RE: ITB #180006299 – FCC - EPDM Roof Replacement

Addendum #1

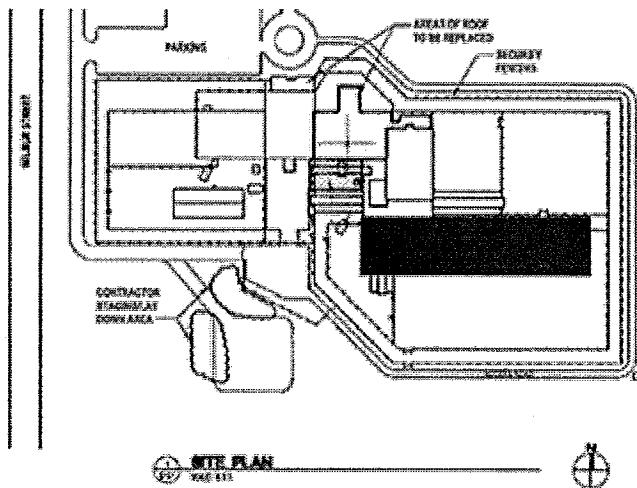
8. Please see the below copied in detail of the Site Plan, 1/G101 of the Contract Drawings. Can the hatched out area be used to stage a demolition dumpster as well as used for a "daily" staging area for materials? This should minimize the amount of gate activity.

A - Yes
